**Re: Permit No. M-1980-244; Cripple Creek & Victor Gold Mining Company; Cresson Project;**  
**Technical Revision 142 – Adequacy Review Response**

On April 11, 2024, Newmont Corporation's Cripple Creek and Victor Gold Mining Company (CC&V) received the Division of Reclamation, Mining and Safety (DRMS) Adequacy Review of Technical Revision (TR) 142 to Permit M-1980-244, regarding the South Cresson Backfill Project. Below are DRMS comments in bold and CC&V's responses in *italics*.

TR142 - FI  
South Cresson Backfill

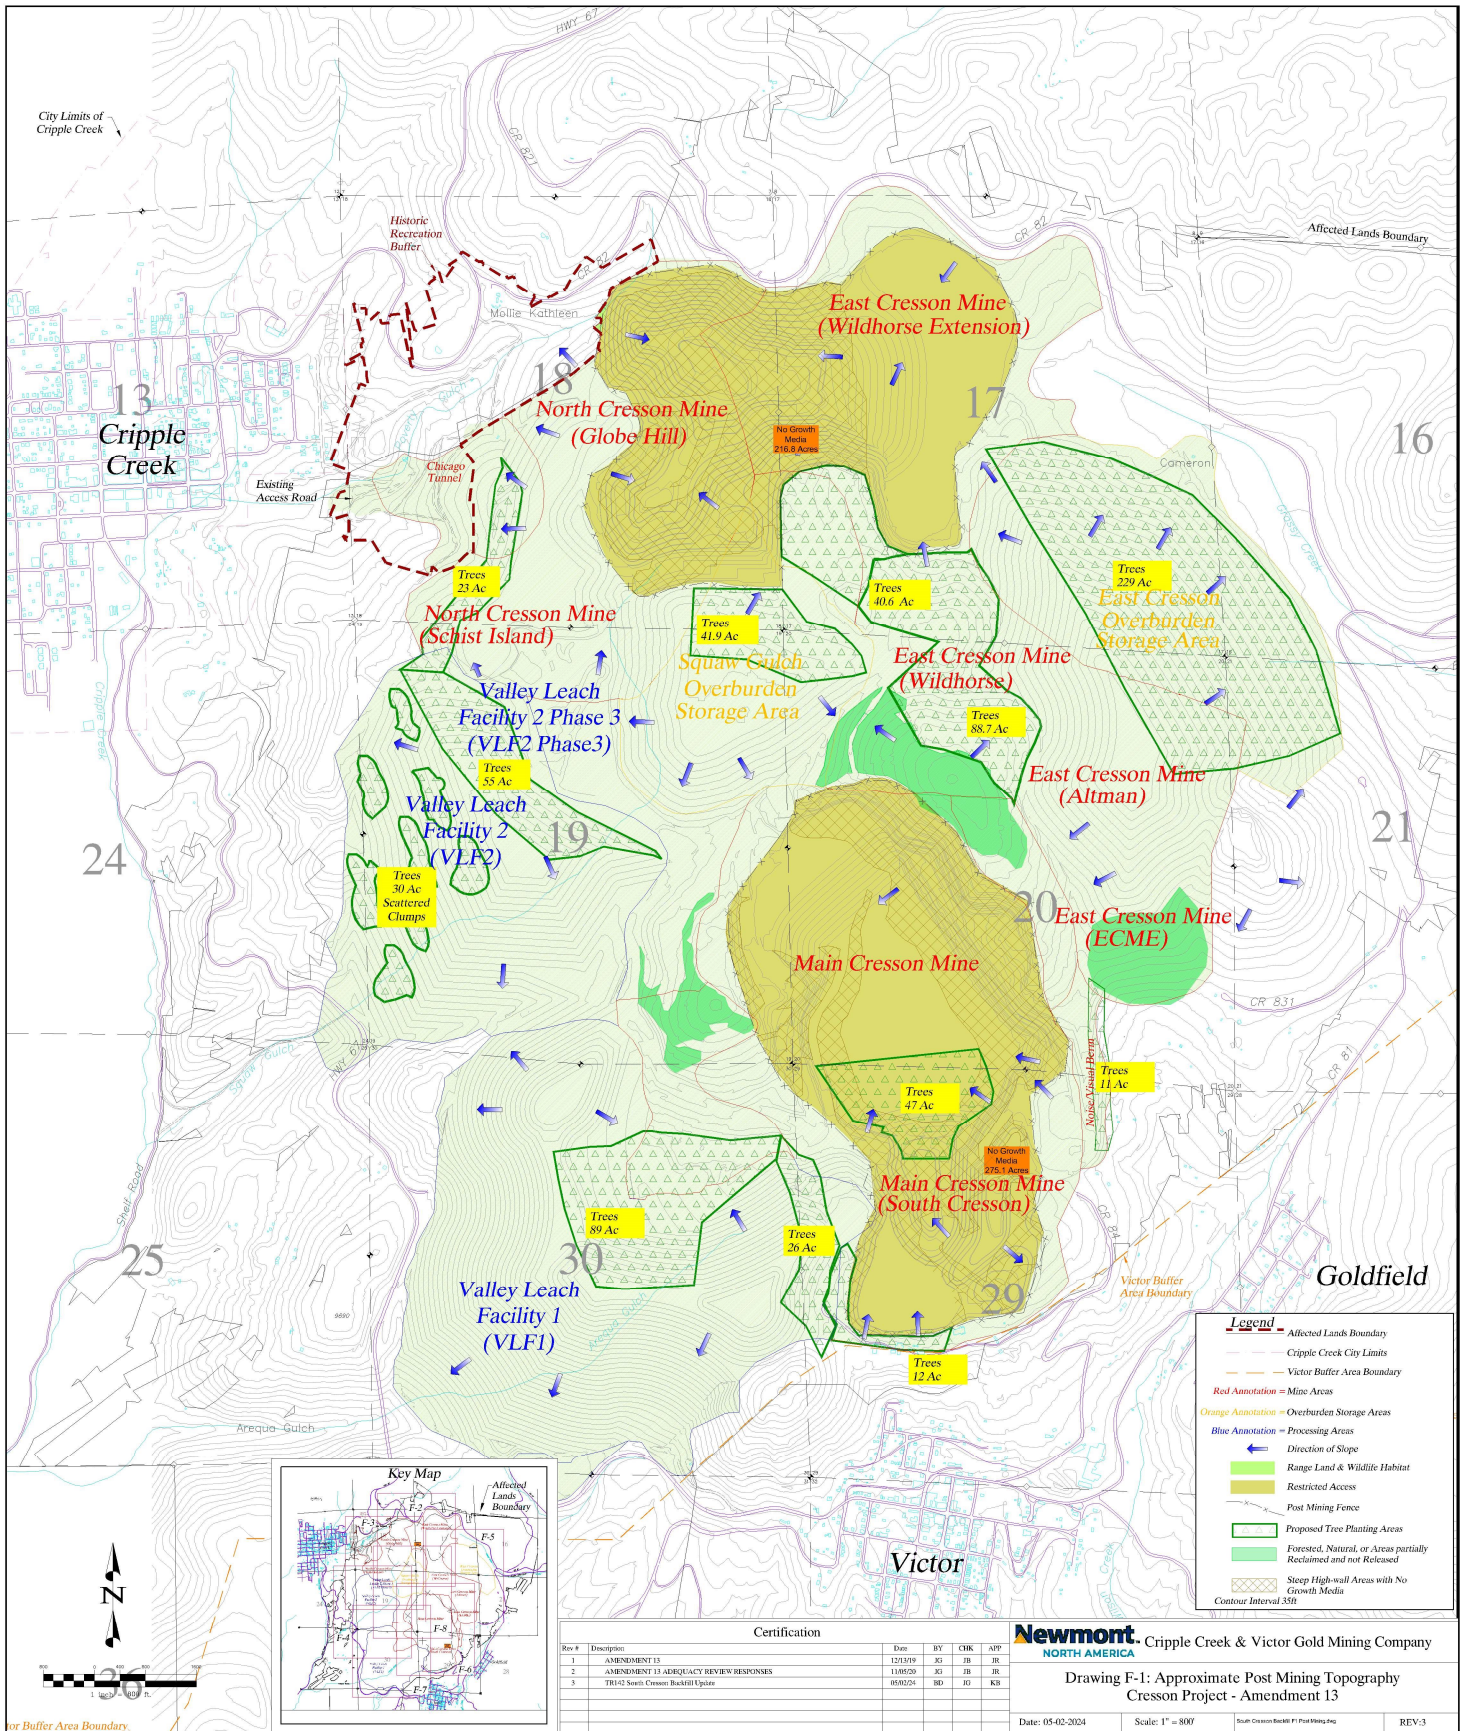
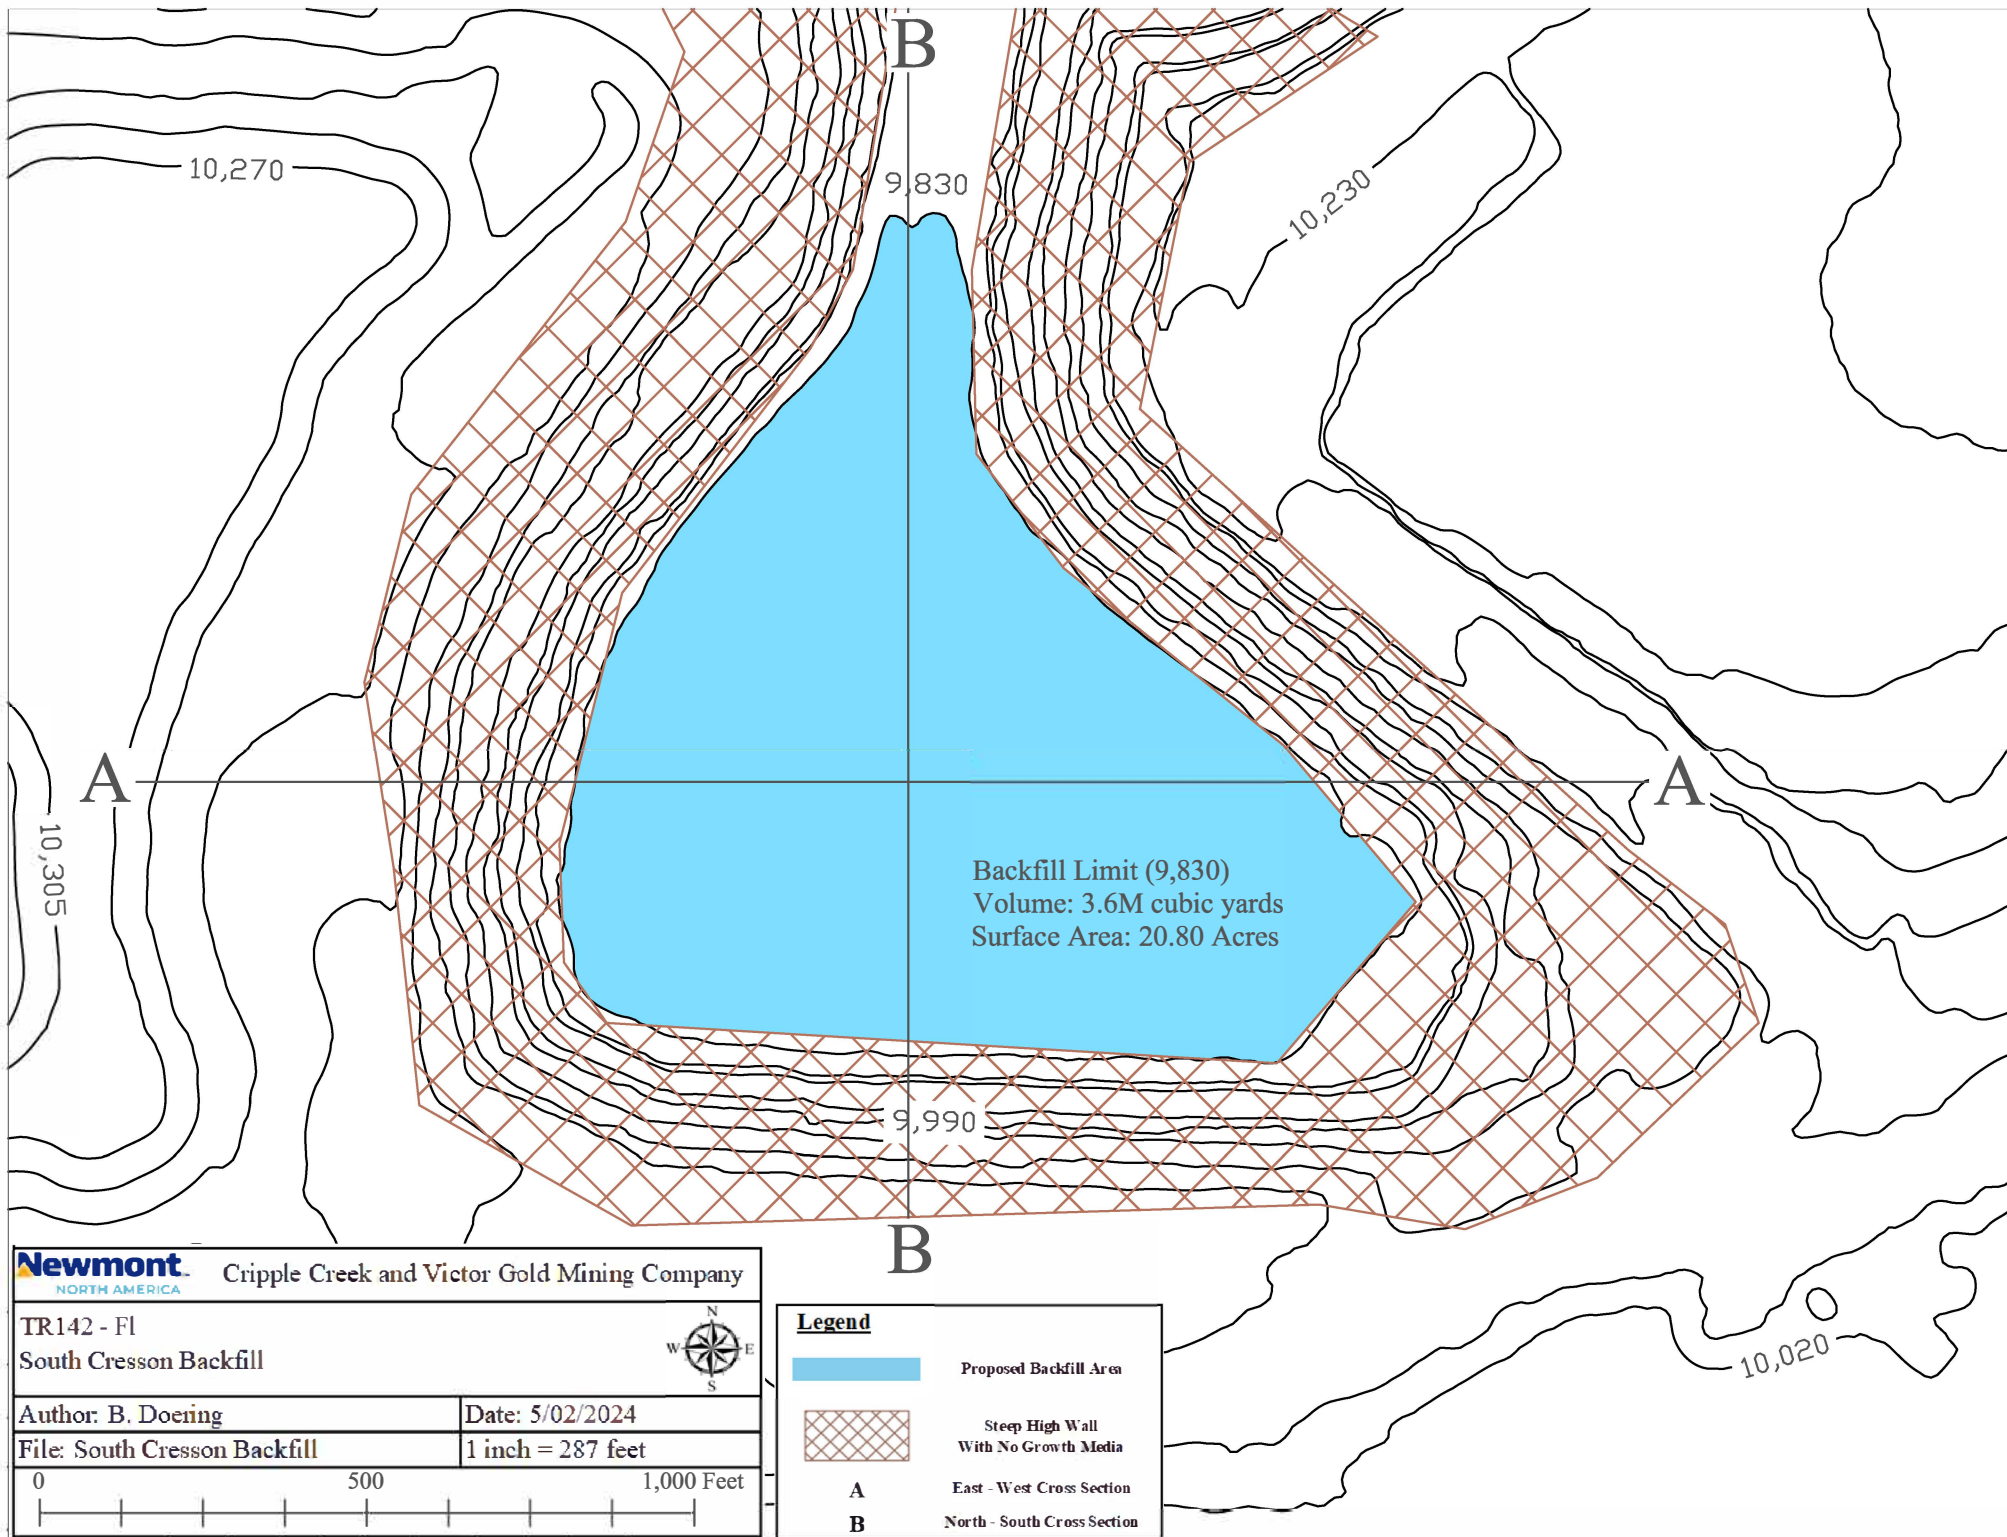
**2. A revised set of Amendment (AM-13) Exhibit F - Reclamation Plan maps are required. Please update these maps to show the proposed final reclamation for the South Cresson Backfill area.**

**6. As previously committed in AM11 and AM13, all accessible haul roads and pit floors will receive growth medium. The western side of the 'Steep High-wall Area with No Growth Media' polygon, between the South Cresson Pit and VLF1 is an accessible haul road. Additionally, because backfill will be placed via truck placement in lifts, this will also be considered an accessible area. Therefore, the Division will require a commitment to placing growth media in this area. Please also refine the 'Steep High-wall Area with No Growth Media' polygon to reflect these areas of accessibility and to show more precisely where a steep high-wall area will remain.**

*The Amendment -13, Exhibit F Reclamation maps that apply to South Cresson are F1 and F6. Please see the attached revised maps.*

*The South Cresson Backfill figure has been updated to reflect that the area between the South Cresson Pit and VLF1 is not excluded from growth medium placement. CC&V commits to placing growth medium within the South Cresson backfill area.*
